# **Public Meeting Maximum Credible Accident Concept and Discussion**

August 4, 2020

# MCA Approach in Aurora FSAR

# MCA Approach in Aurora FSAR

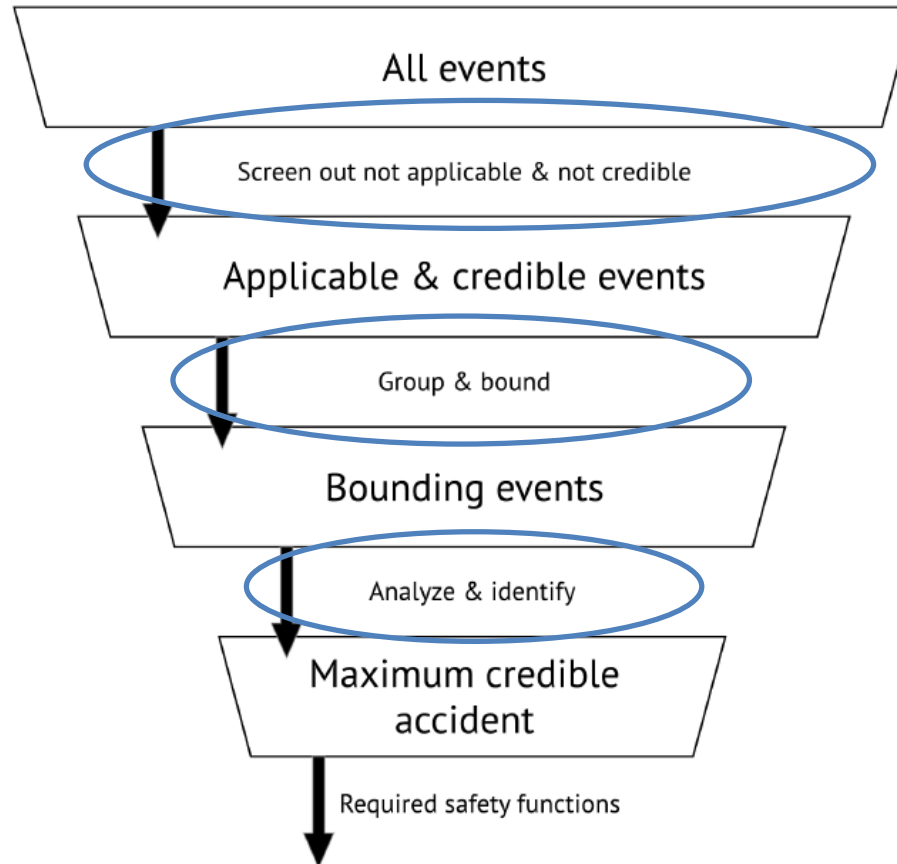
NRC staff needs additional information on the application of the MCA analysis approach as described in FSAR Sections 5.5 and 5.6
